SPECIFICATIONS AND DRAWINGS
HOUSING AUTHORITY OF THE CITY OF LUMBERTON: TURNER TERRACE
REPAIR OF FLOOD-DAMAGED UNITS
TWC # 3313-B 03

SUBJECT: ADDENDUM NO. 2

MAY 9, 2019

To the Plans and Specifications for:
Housing Authority of the City of Lumberton: Turner Terrace
Repair of Flood-Damaged Units

E103

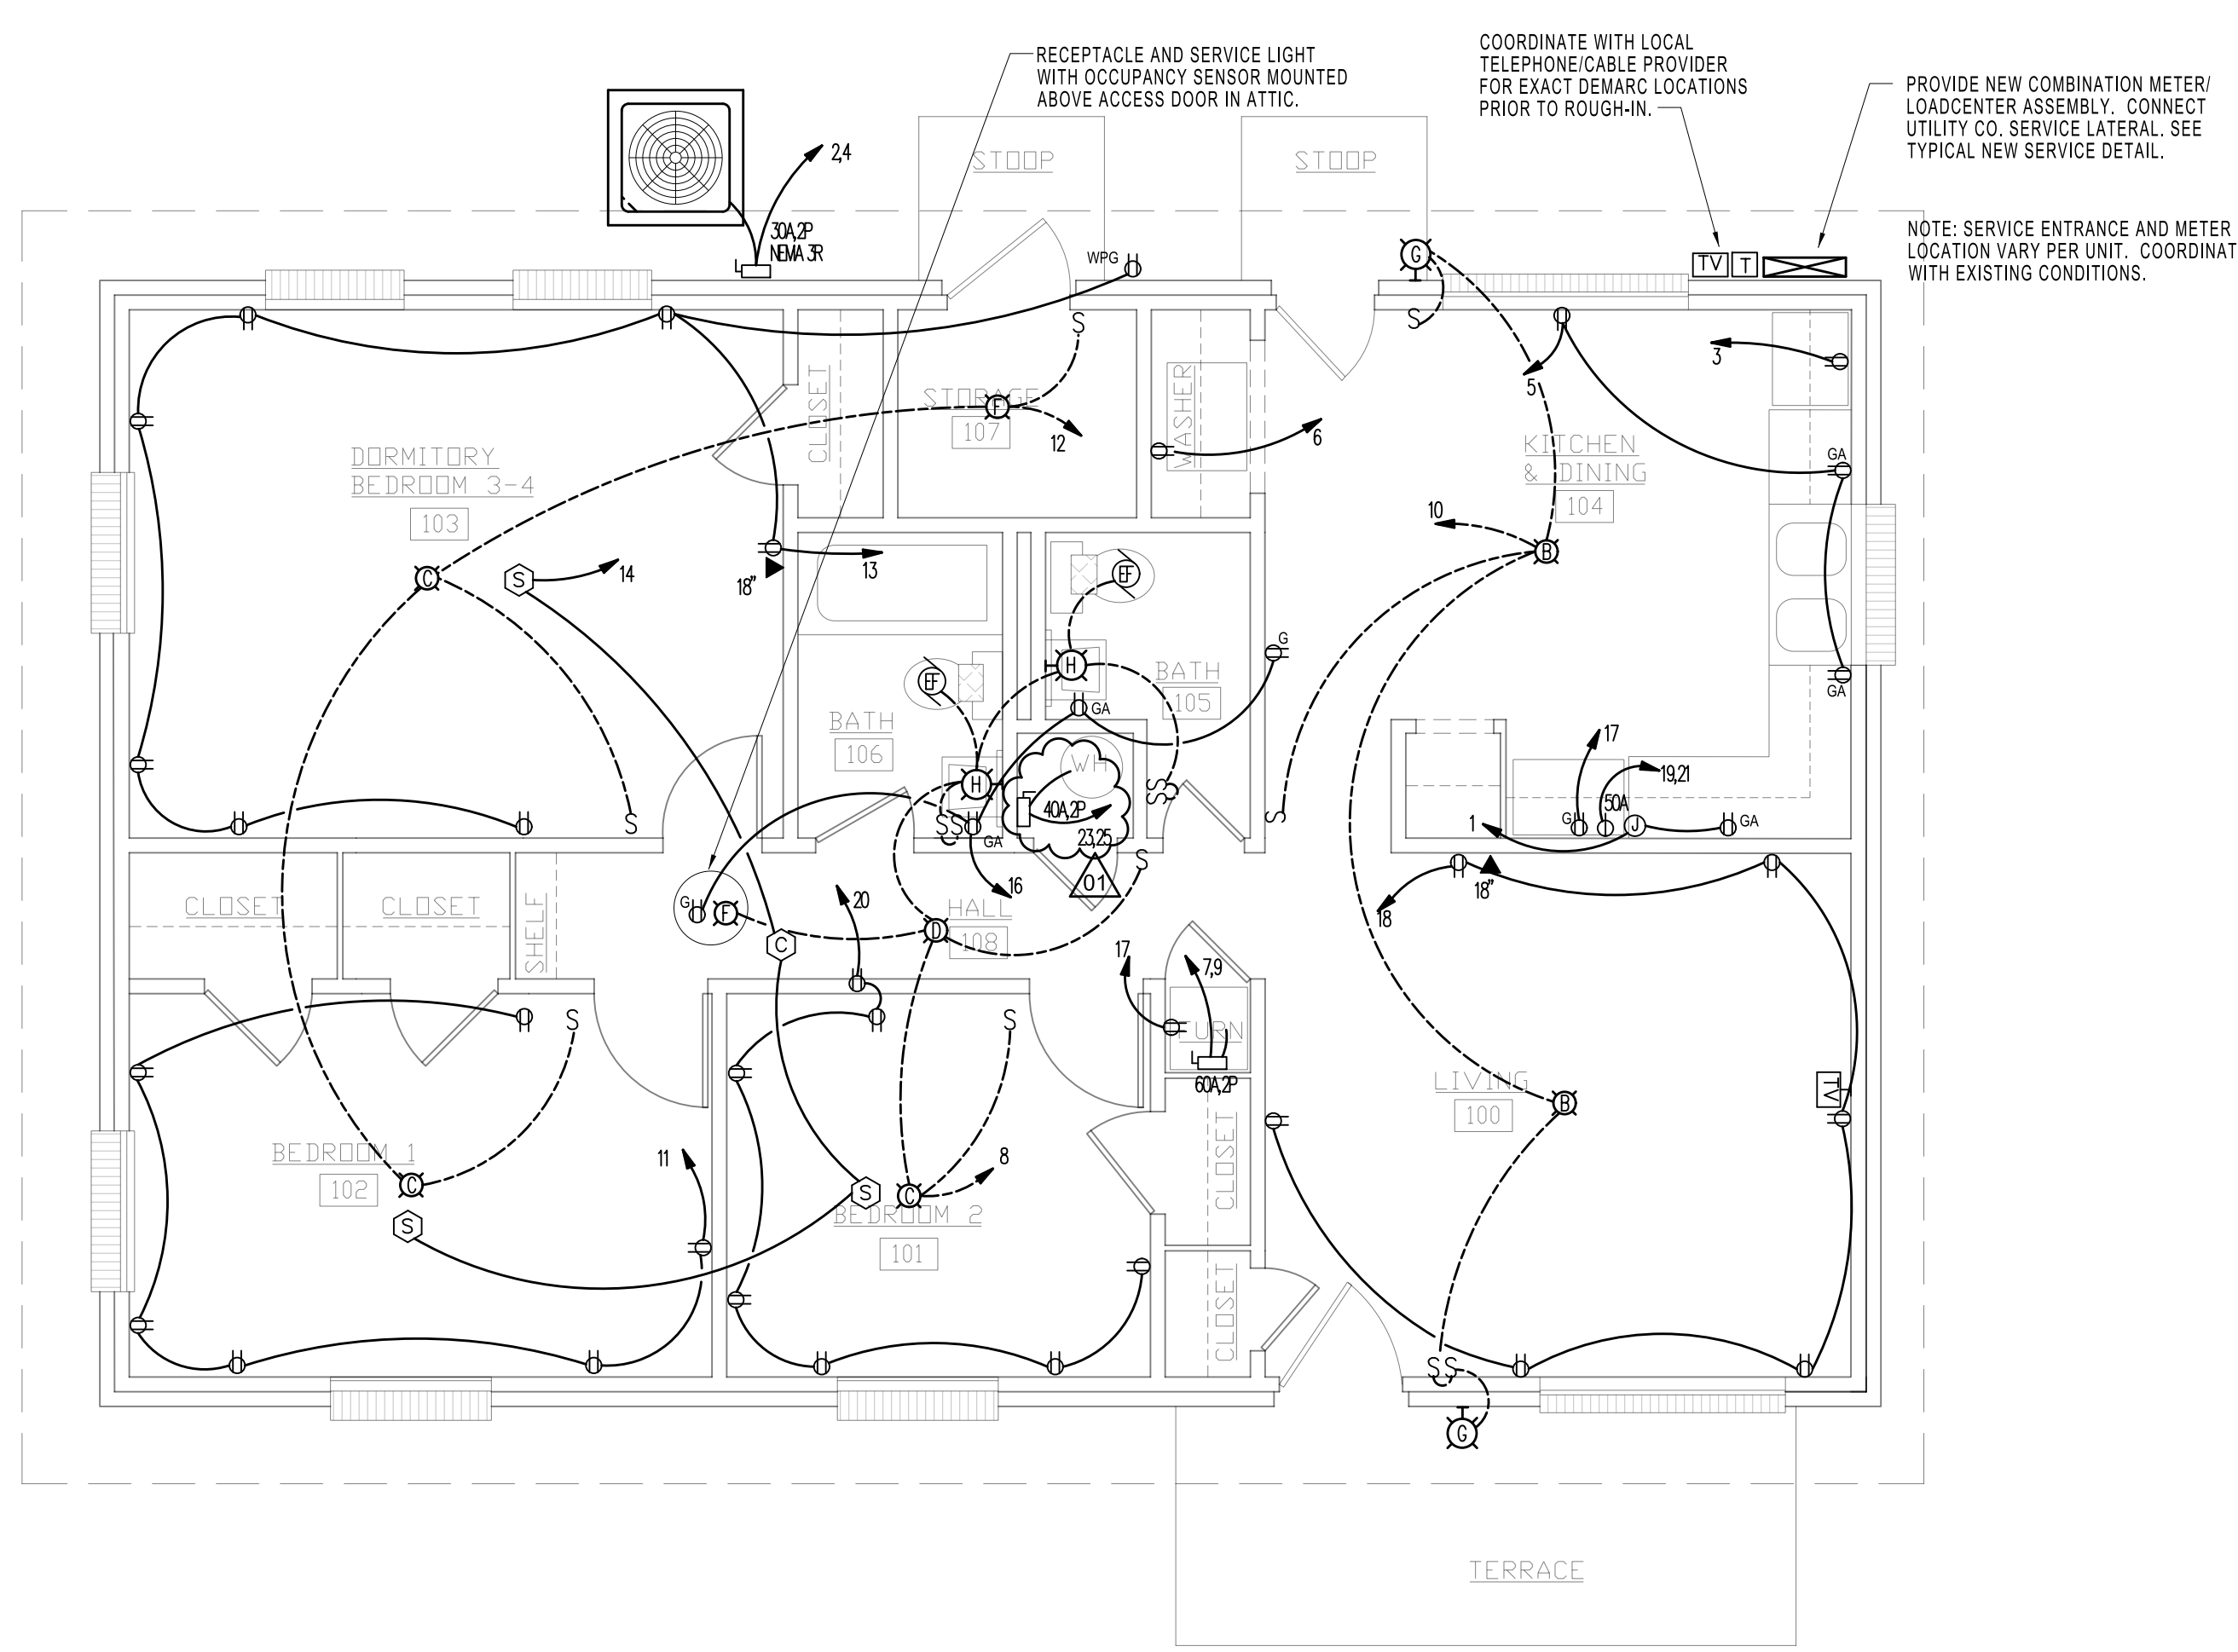
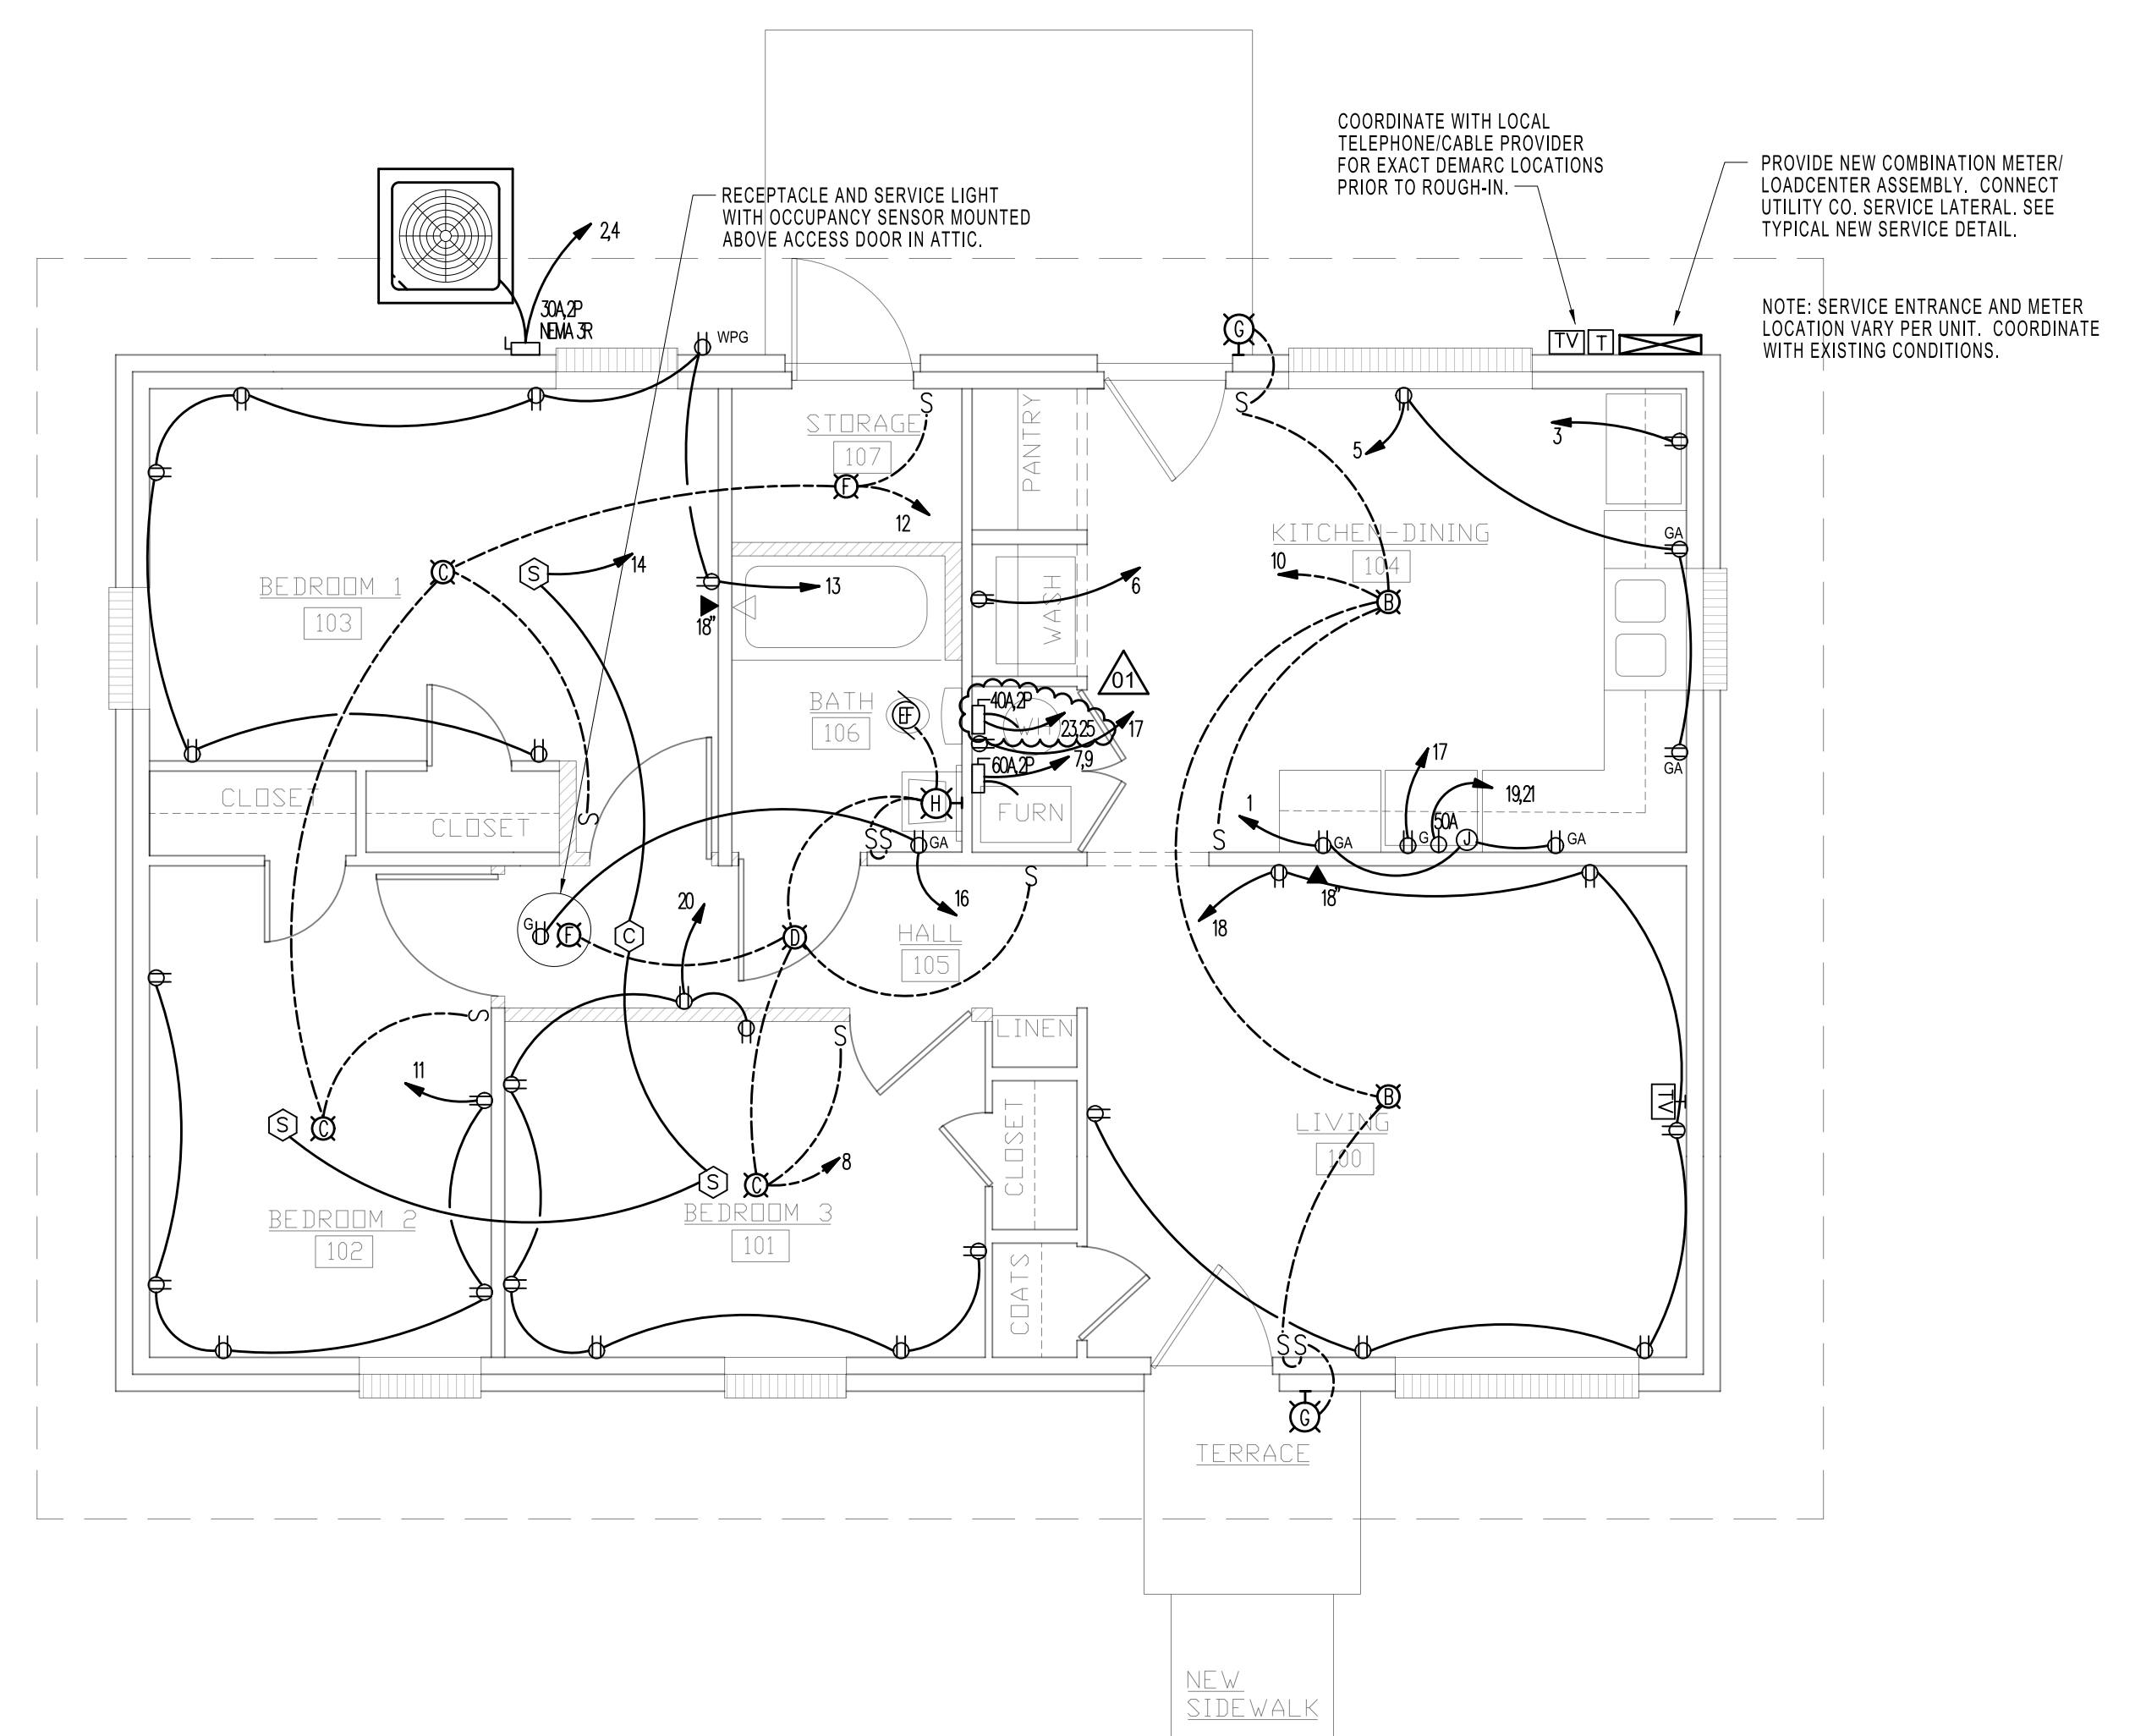
- a. Replace with attached.
 - b. 1/E103: Add circuit for electrical water heater.
 - c. 2/E103: Add circuit for electrical water heater.
10. Sheet E104
 - a. Replace with attached.
